**PARK CITY REGULAR PLANNING COMMISSION MEETING
SUMMIT COUNTY, UTAH
October 20, 2021**

- 4.A. Park City Mountain Resort Base Parking Lots - MPD Modification Work Session- Replace Expired Exhibit D of the DA, the 1998 PCMR Base Area Master Plan Study Concept Master Plan, With a New Master Plan, Known as the Park City Base Area Lot Redevelopment Master Plan Study. The Commission Will Discuss Off-Site Parking and Transportation, Draft Findings of Fact, Draft Conditions of Approval and Other Issues Raised in the Staff Report. PL-20-04475.

**PARK CITY MUNICIPAL CORPORATION
PLANNING COMMISSION MEETING MINUTES
COUNCIL CHAMBERS
MARSAC MUNICIPAL BUILDING
September 29, 2021**

Planning Commission Staff Report

PARK CITY MOUNTAIN RESORT
BASE AREA MASTER PLAN

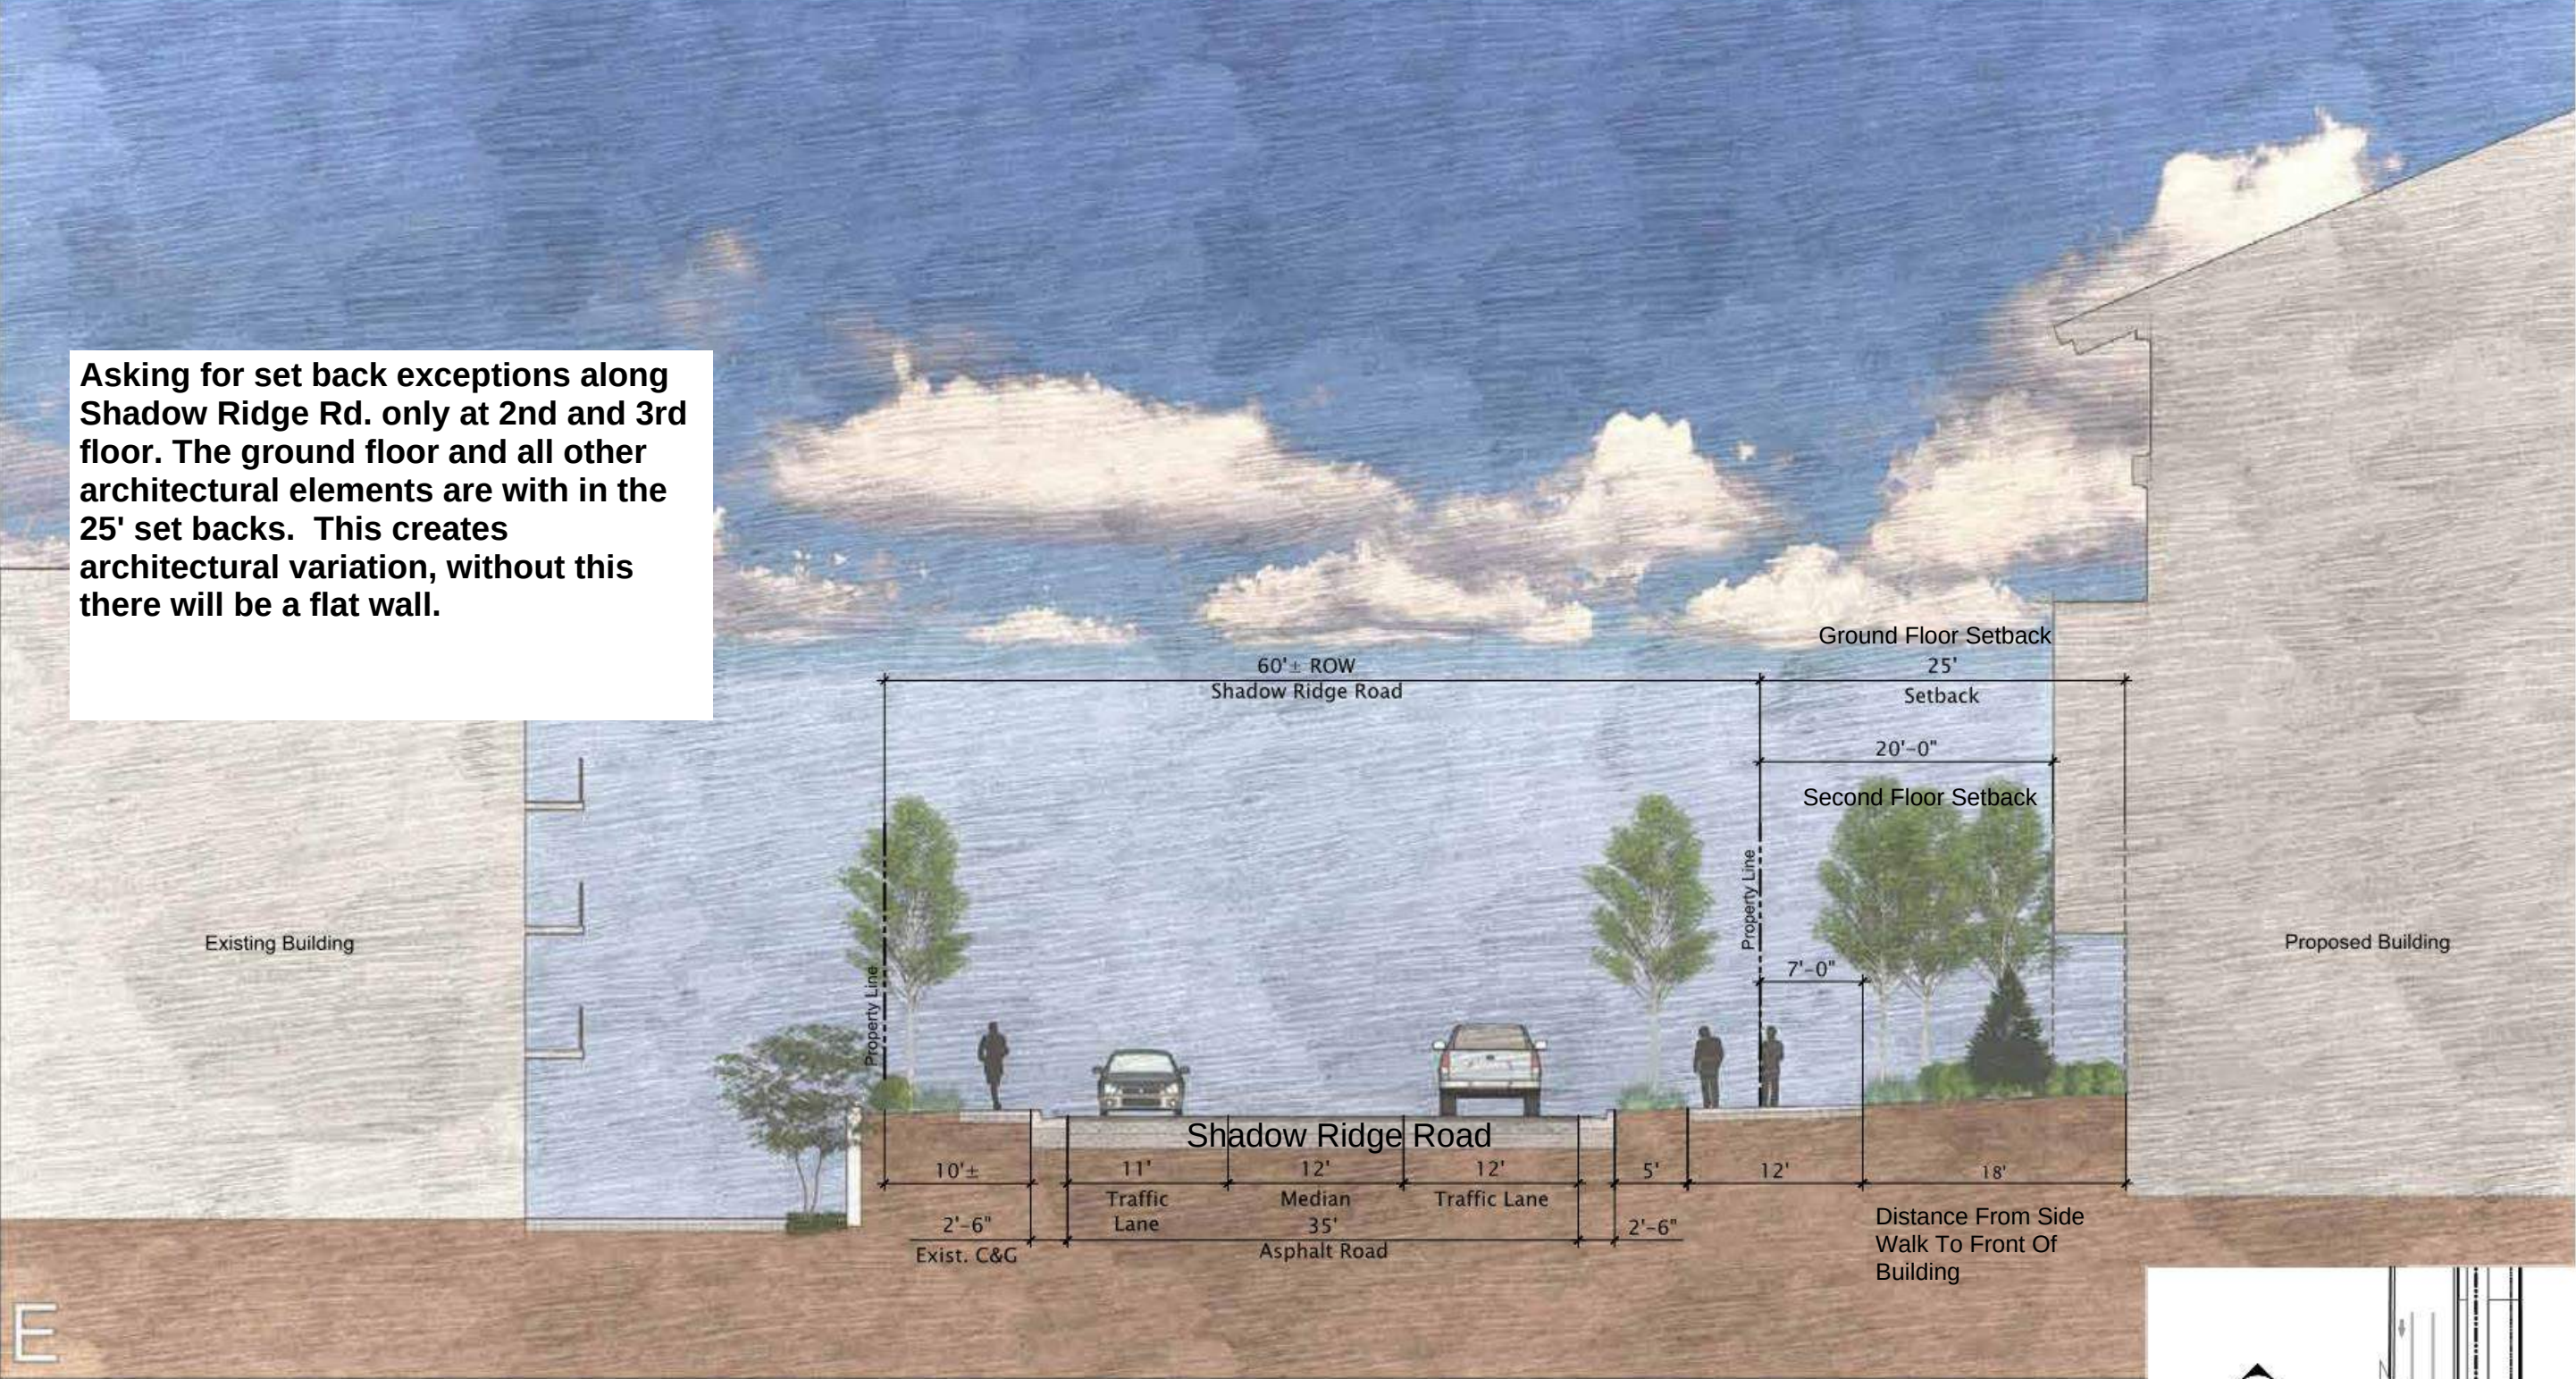
Asking for set back exceptions along Shadow Ridge Rd. only at 2nd and 3rd floor. The ground floor and all other architectural elements are with in the 25' set backs. This creates architectural variation, without this there will be a flat wall.

SECTION C - LOWELL AVENUE
NTS

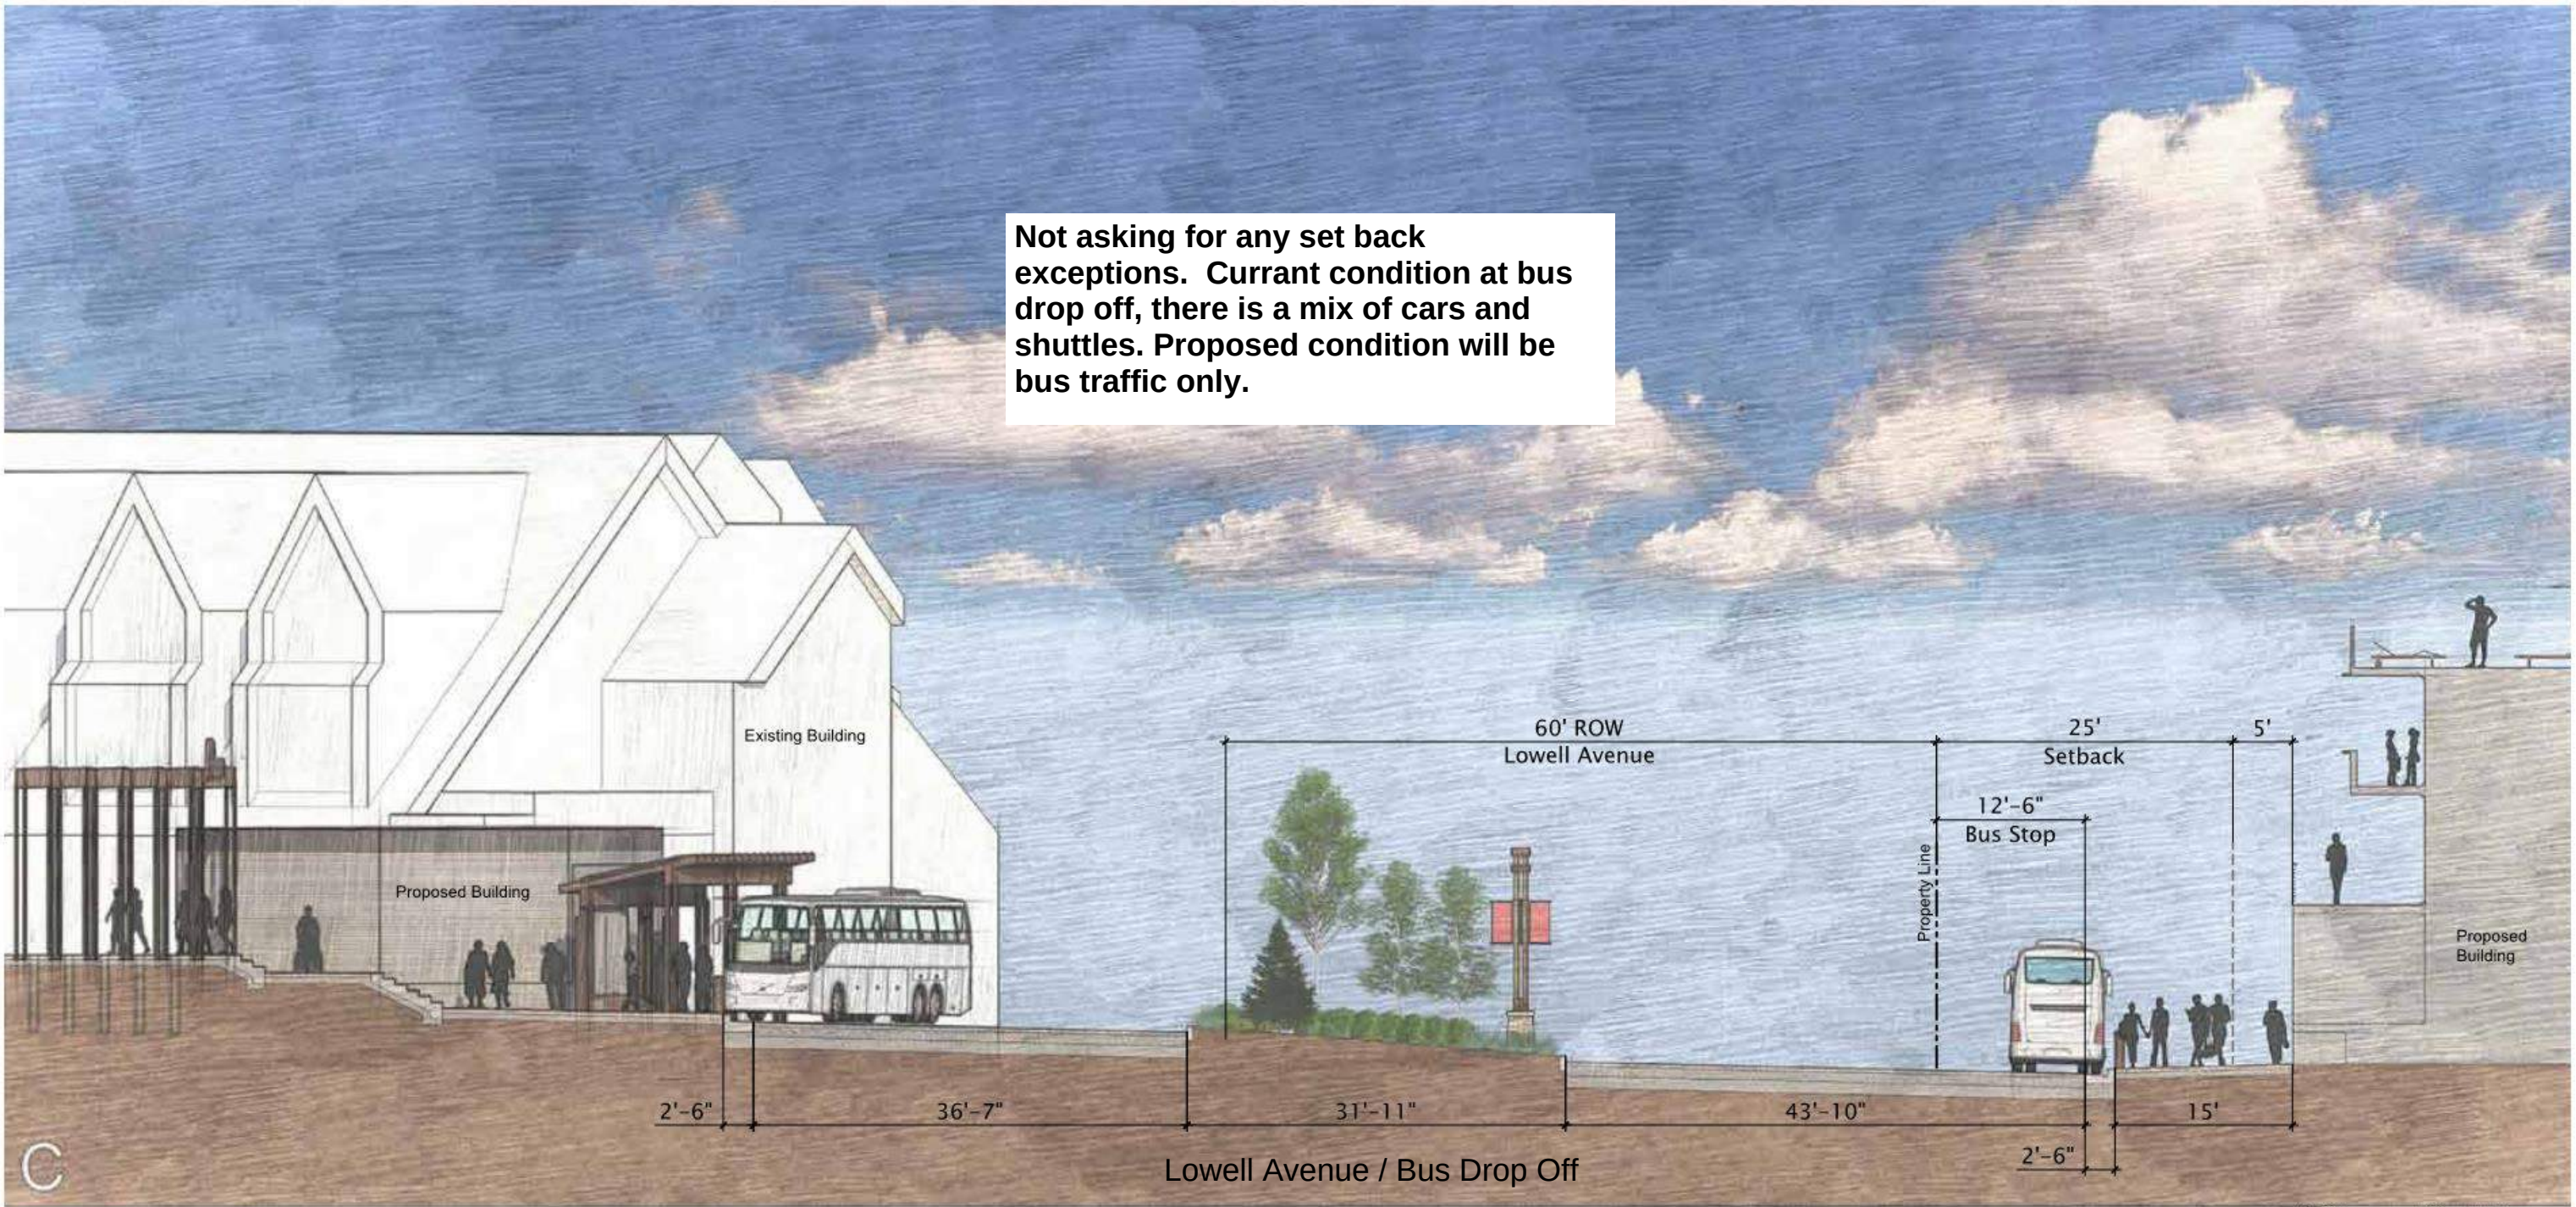
Not asking for any set back exceptions. Currant condition at bus drop off, there is a mix of cars and shuttles. Proposed condition will be bus traffic only.

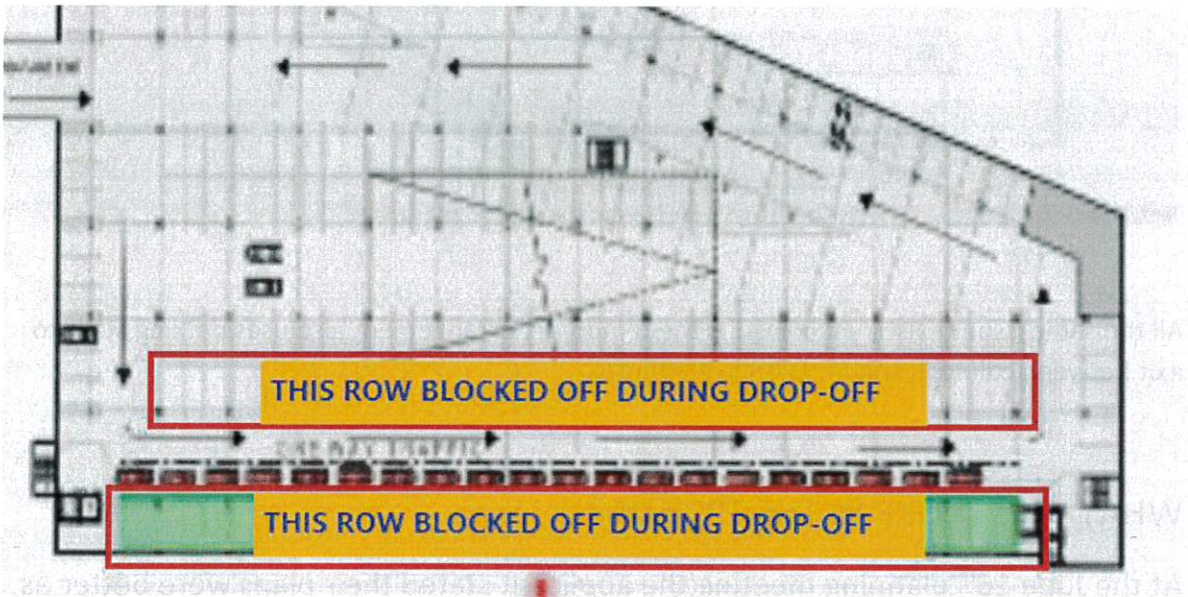
This is exemplified, not only by the missing skier service amenities, but also the lack of dedicated drop-off and pick up that is now proposed in a vastly compromised solution of underground parking garages, that are disjointed from the slopes, and with their own set of issues (see attached file).

BUILDING E

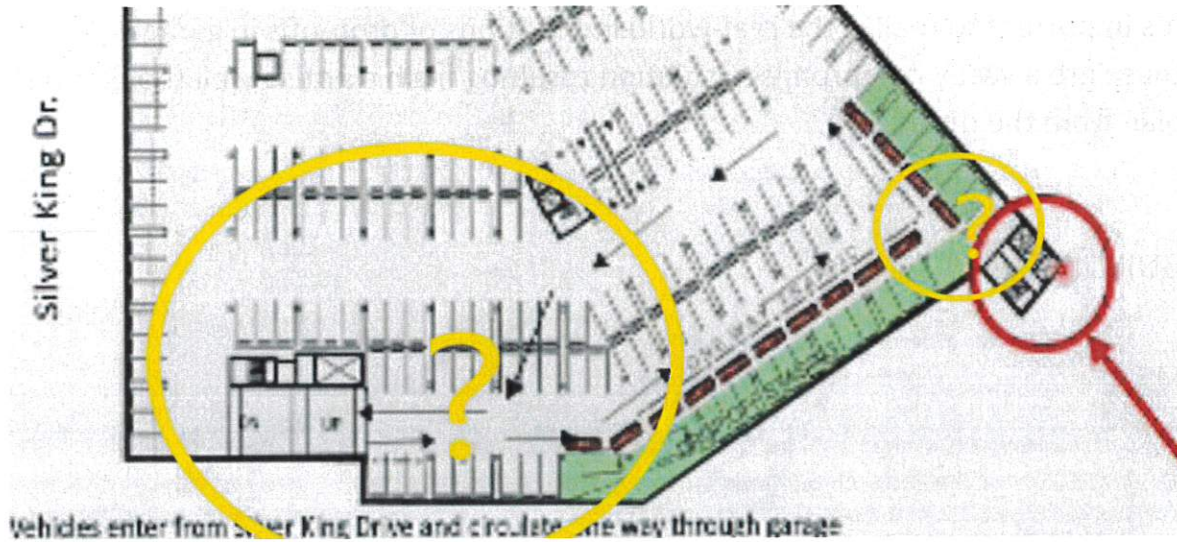
All the same issues exist in building E – the temporary arrangement also uses parking stalls to exit between columns and impossible geometry.

1998 PLAN BUILDING C EXHIBIT

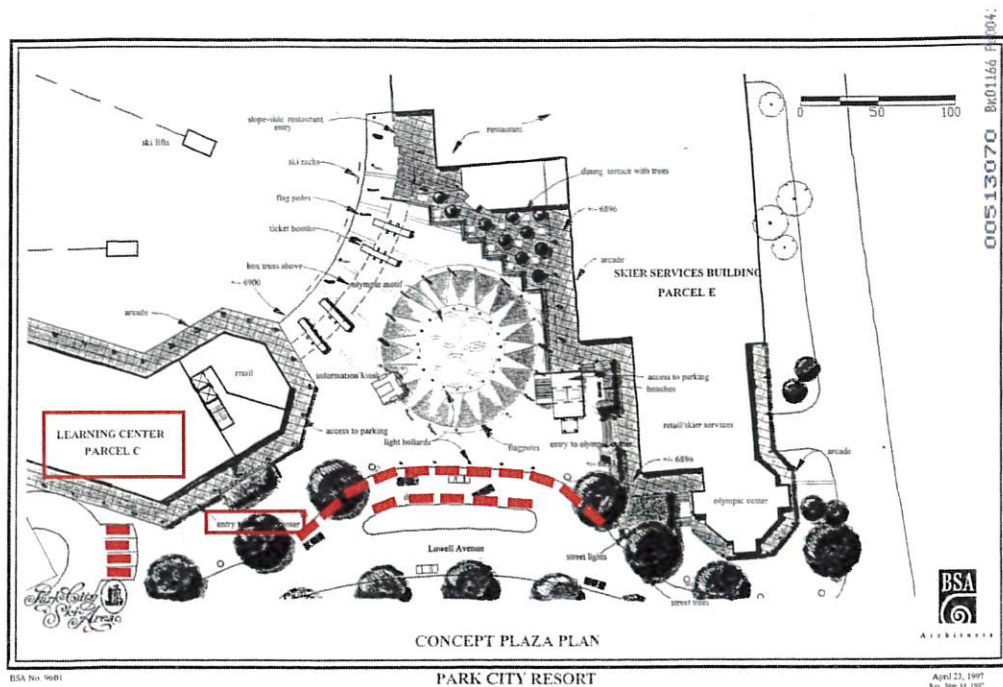
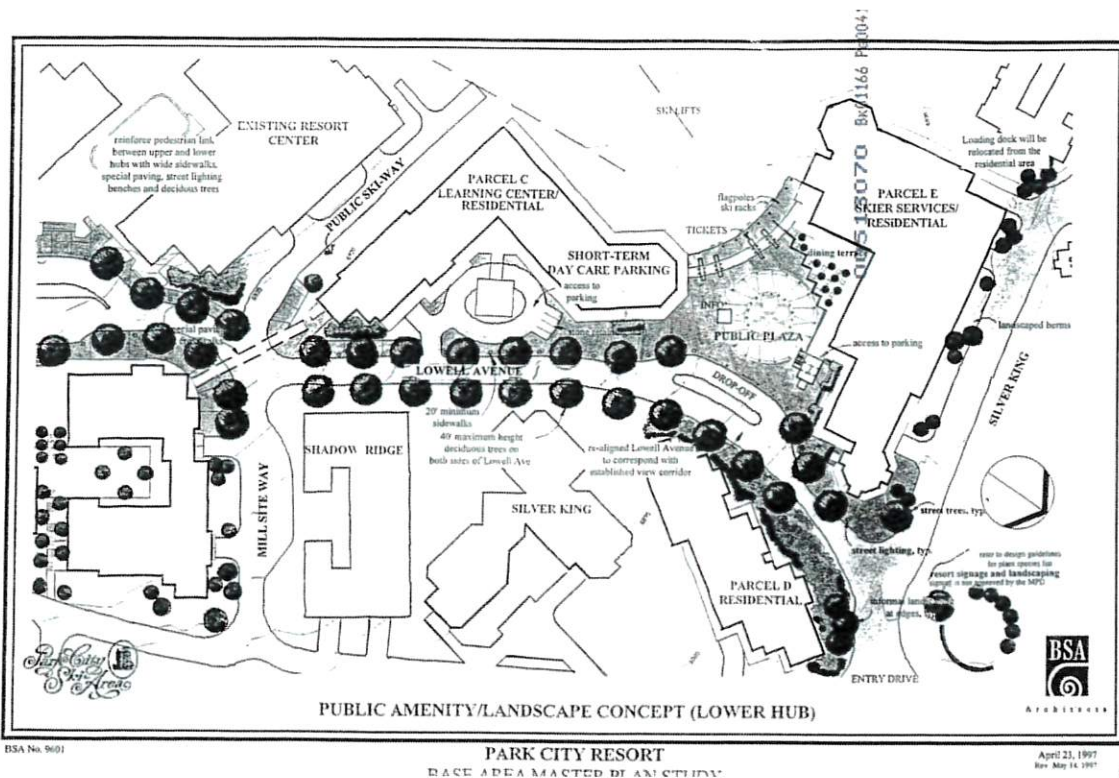
At the June 16th planning meeting the applicant stated their plans were better as they accommodated 8 vehicles while only counting 4 on the 1998 exhibit?

1. The 1998 DA plans reserved 16 DEDICATED drop-off & PICK-UP spaces and 4 DEDICATED short term parking spaces.
2. The 1998 DA plans provide a zone that does not impede any through lanes.
3. The 1998 DA plan put these spaces right next to a learning center, ski school, day care, as well as other skier service amenities that the community bargained for at that time.
